Carmel Valley Association

Subject: 2016 “Recirculated Draft Environmental Impact Report” for
Rancho Canada Village subdivision application

Carmel Valley Association comments:
“Recirculated Draft EIR” Rancho Canada Village Project
August 31, 2016
Page 2 of 50

Figure 1. Plot of 15-minute-interval daily traffic volumes on Highway 1 from Ocean Ave. to Carmel Valley Rd. The highest sequential volumes occur near mid-day. The RDEIR incorrectly assumed that peak periods are 7-9 am and 4-6 PM, those periods shown as dotted red lines.

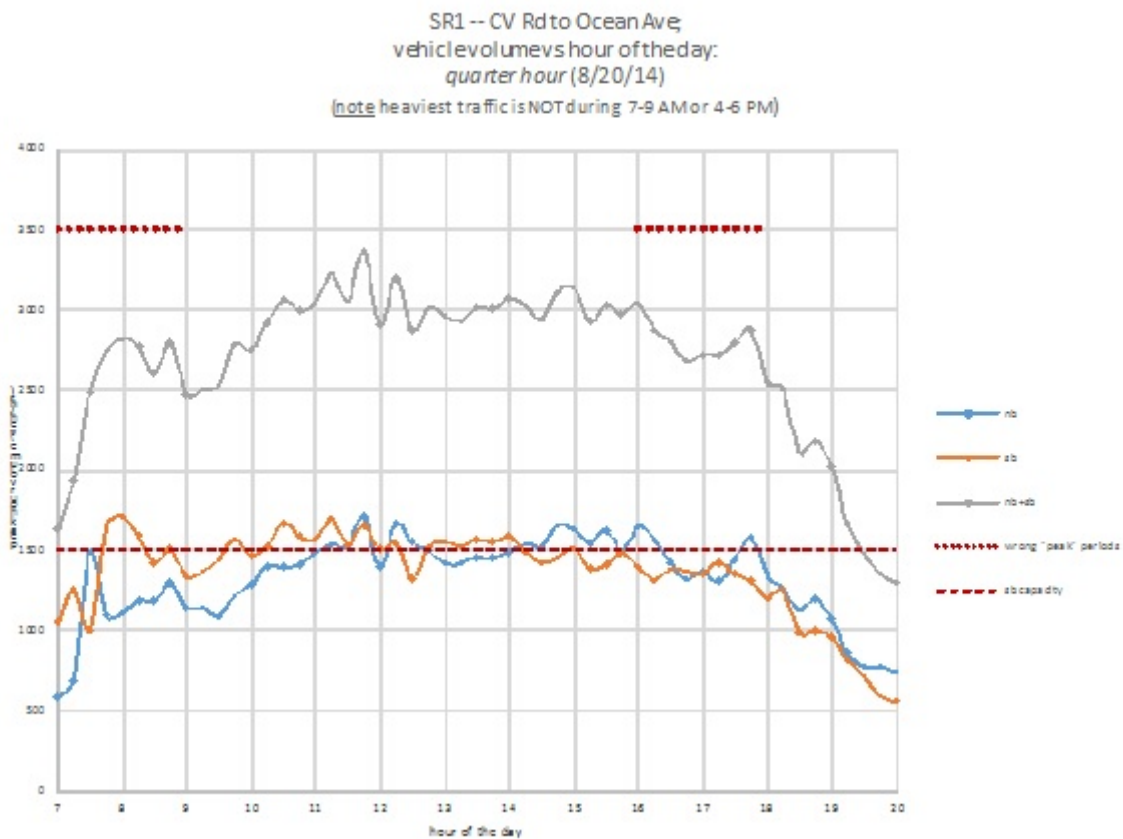
which taints the entire traffic impact analysis, underestimates impacts, and renders useless results. (See Figure 1 and its caption. The graph is provided by CVA, based on the RDEIR data on pdf p. 886.) This is one example among many of the RDEIR’s improper and inadequate methodology.

The RDEIR analysis assumed that periods of peak traffic were between 7 and 9 AM and between 4 and 6 PM (see RDEIR p. 3.7-9; also RDEIR Appendix E pp. 1, 3). The assumption is not supported. Total traffic on the Ocean Ave.-to-Carmel Valley Rd. segment of SR1 was not at its peak during those hours. It peaked at 11:45 AM with significantly higher volume (see Figure 1 in this letter) than during the 7-9 AM and 4-6 PM periods. Thus, the RDEIR assumed peak periods that do not comport with actual data reported in the RDEIR traffic study.

Figure 1 in this letter uses the RDEIR’s own data. Figure 1 shows that the traffic quarter-hours of 10:15 am to 4 PM each contain cumulative traffic (NB and SB) higher than or approximately equal to the highest cumulative traffic counts during the RDEIR-claimed “peak hours” of 7-9 am and 4-6 PM.

The differences between actual peak traffic times and assumed peak traffic times, and the consequent differences in traffic volumes that are based on those different times, would significantly and materially change the conclusions of the traffic analysis, both for segments analyses and for intersections analyses. It is impossible to quantify the differences without (1) accurate reporting of the times of actual observation of the traffic and of (2) the observed volumes at those times. The RDEIR peak hour results are based on the incorrectly assumed and vague two- hour peak periods. No evidence was provided to support the assumed peak period choices.

F. HYDROLOGY

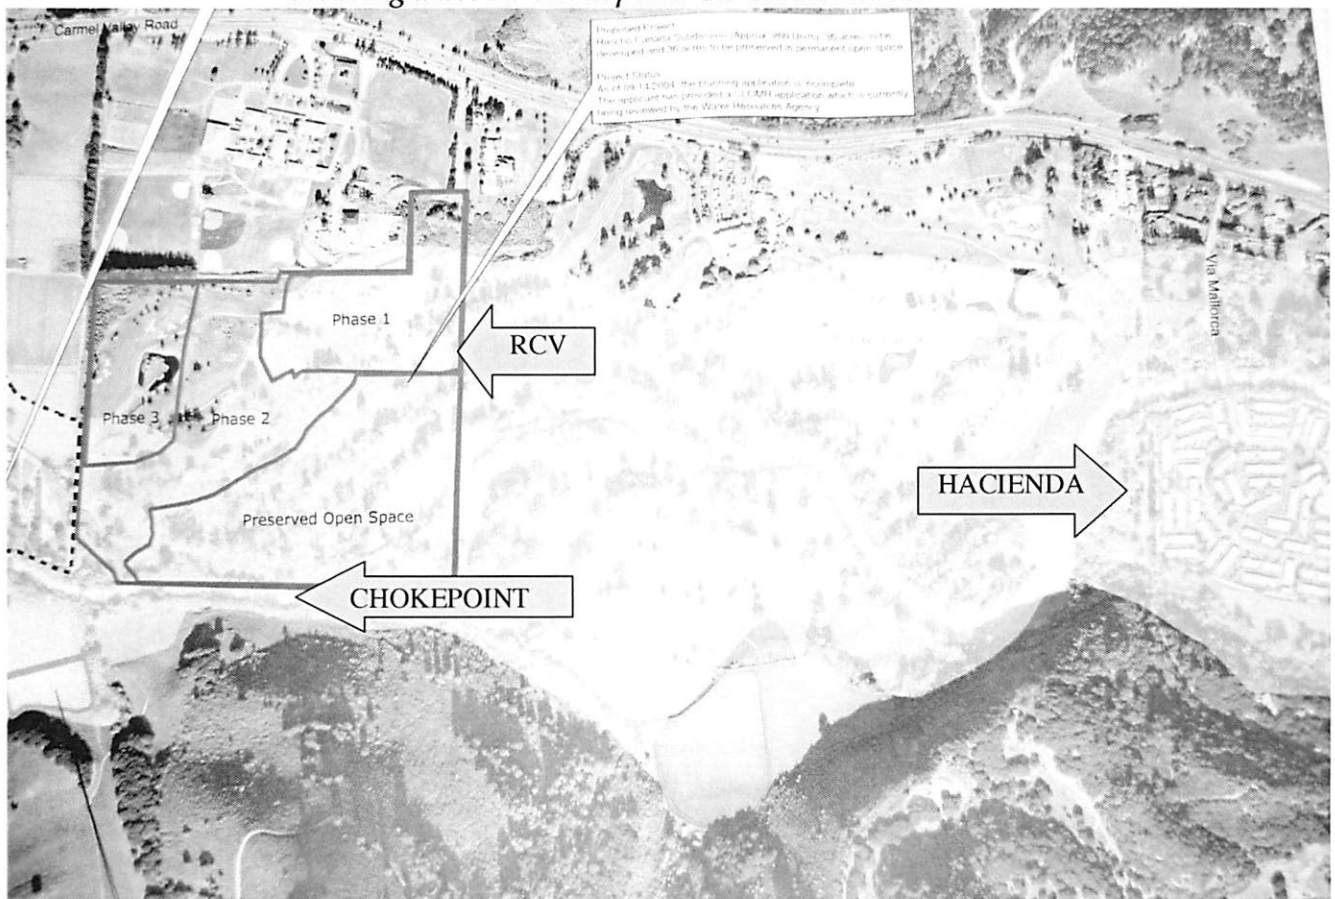
The DEIR significantly fails to address major flooding problems associated with the project, both in terms of upstream flooding as a result of the virtual earthen dam that is to be created as part of this project, and as a result of the impact of the newly displaced 100,000-200,000 cubic yards of water in a major flood event. The major fatal hydrology flaw in the DEIR is that it fails to analyze in a serious way - or at all - the potential flood impacts from the project on properties upstream and downstream from RCV.

At least two critical sets of impacts arise from the RCV fill plans on hydrology:
